UNITED STATES
DEPARTMENT OF THE INTERIOR
BUREAU OF LAND MANAGEMENTFORM APPROVED
OMB NO. 1004-0137
Expires: January 31, 2018**SUNDRY NOTICES AND REPORTS ON WELLS**
*Do not use this form for proposals to drill or to re-enter an abandoned well. Use form 3160-3 (APD) for such proposals.*5. Lease Serial No.
NMNM99041

8. Well Name and No.
SPRUCE GOOSE FEDERAL 19. API Well No.
30-025-3844510. Field and Pool or Exploratory Area
LUSK; BONE SPRING, NORTH11. County or Parish, State
LEA COUNTY COUNTY, NM**SUBMIT IN TRIPLICATE - Other instructions on page 2**

Permanent Abandonment of Federal Wells
Conditions of Approval (LPC Habitat)

Current
Wellbore Diagram

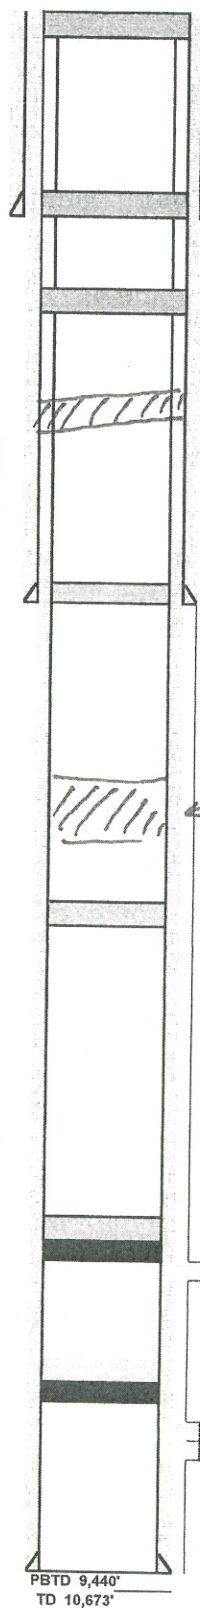
6. Perf & Sqz 50 sx cmt @ 1384-1164'. WOC & Tag (B/Salt) *(T. Salt @ 1150')*

(2600' - 2514') Perf & sqz. TAG
45 sx
(Yates @ 2590')

(4918' - 4768') spot 25 sx
Delaware @ 4868'

4. Spot 25 sx cmt @ ~~5000-4800'~~ (Bone Spring) @ 6887'
(6937' - 6767')
